UNITED STATES  
NUCLEAR REGULATORY COMMISSION  
WASHINGTON, D. C. 20555

SUBJECT: INTEGRATED DESIGN INSPECTION 50-400/84-48, Supplement 1

CAROLINA POWER & LIGHT COMPANY  
SHEARON HARRIS NUCLEAR POWER PLANT  
MCB - CONDUIT AIR GAP ANALYSIS

Subject: SHEARON HARRIS NUCLEAR POWER PLANT  
INTEGRATED DESIGN INSPECTION (IDI)  
MCB, AEP-1 & ACP - CONDUIT AIR GAP ANALYSIS

FCR AS-10,306  
PAGE 3 OF 4

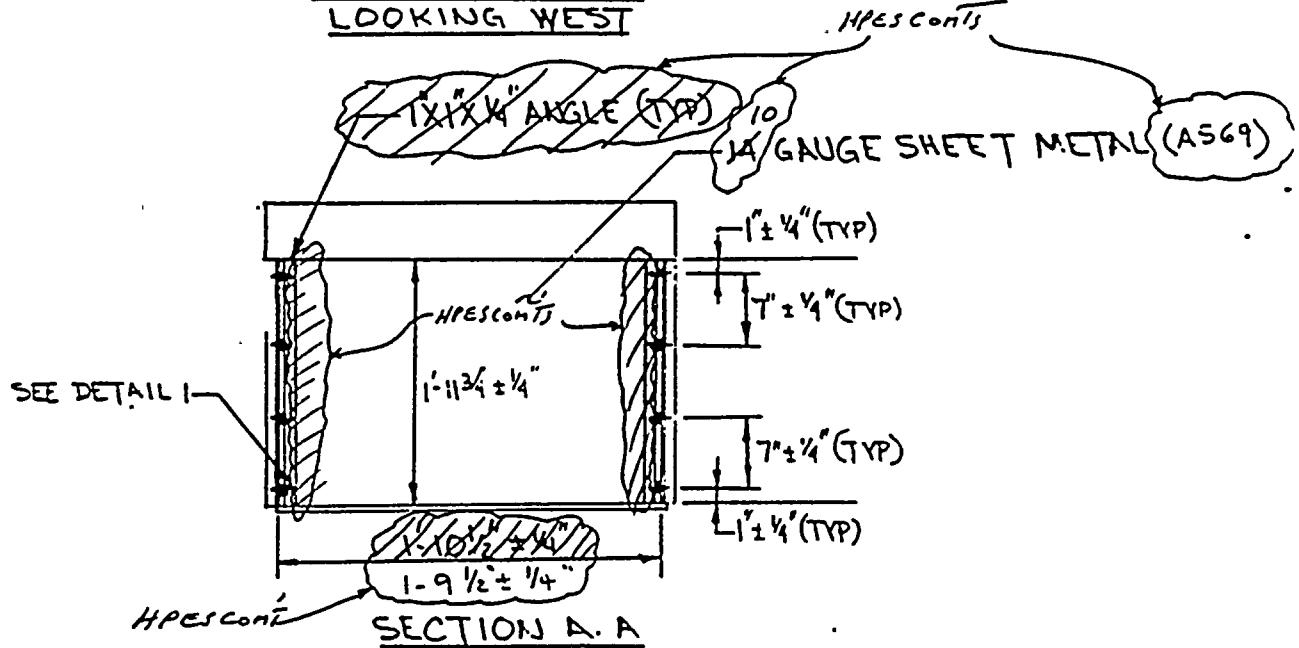
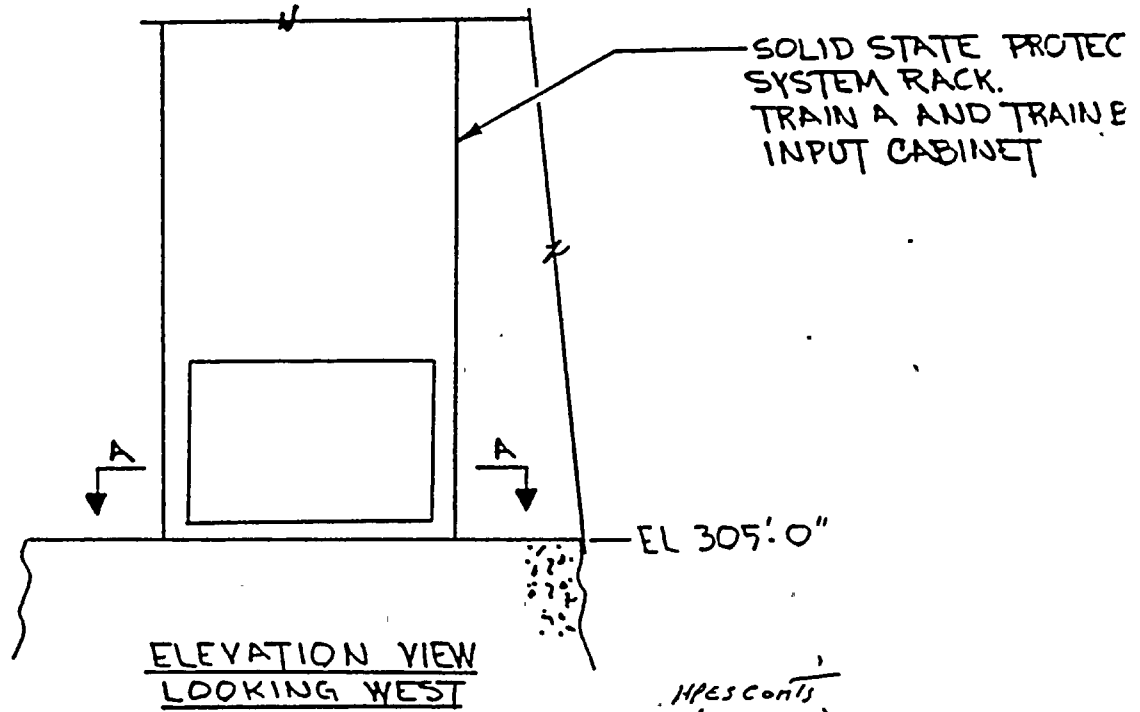
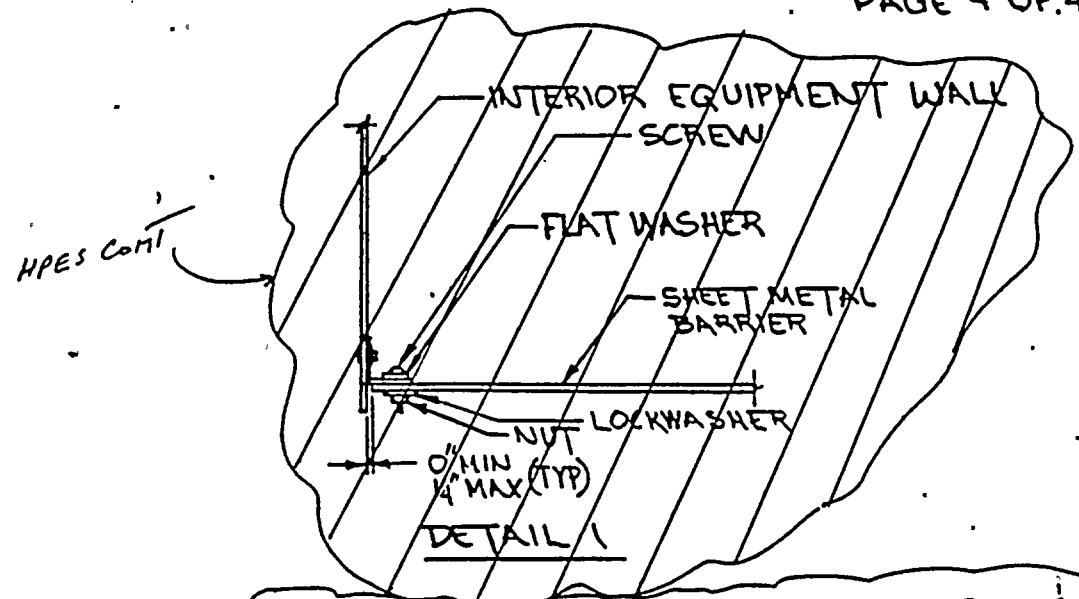
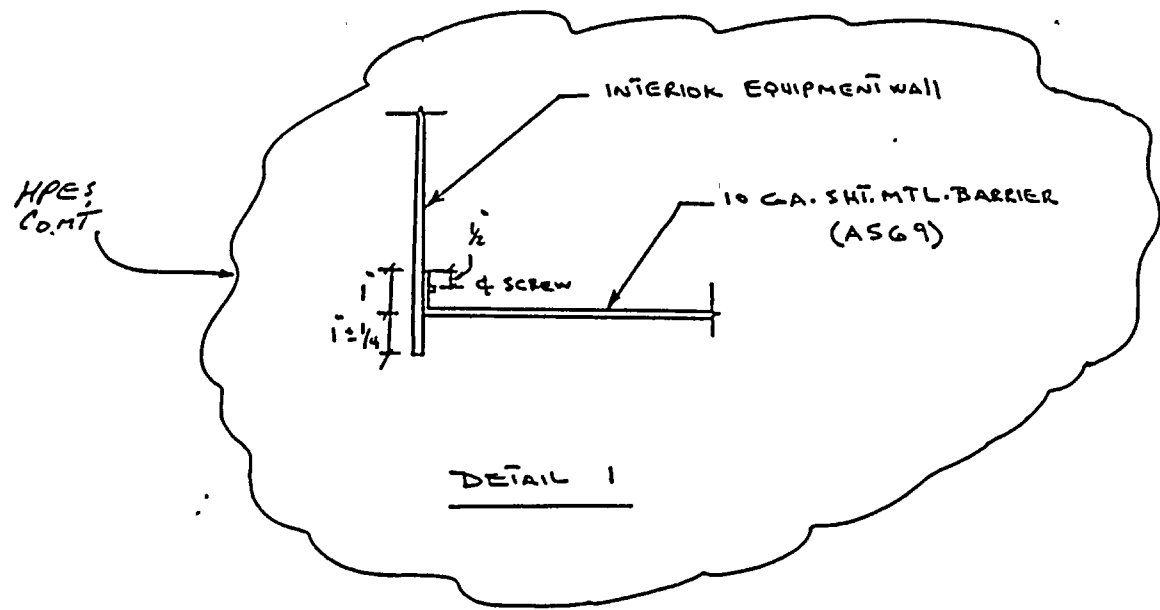
Description CABLE SEPARATION IN SSP INPUT CABINETS - TRAIN A AND TRAIN B

A BARRIER IS NEEDED FOR CABLE SEPARATION IN SSP INPUT CABINETS TRAIN A AND TRAIN B

INSTALL BARRIER AS SHOWN ON PAGE 3 AND 4

NOTES: 10 GAGE SH. MTL. TO BE FABRICATED AS SHOWN BELOW  
~~2 X 1 X 1/4" ANGLE IRON~~ TO BE ATTACHED TO INTERIOR  
WALL BY DRILL AND TAPPING WALL AND USING #10-24 SILICON  
BRONZE SCREWS AND FLAT WASHERS
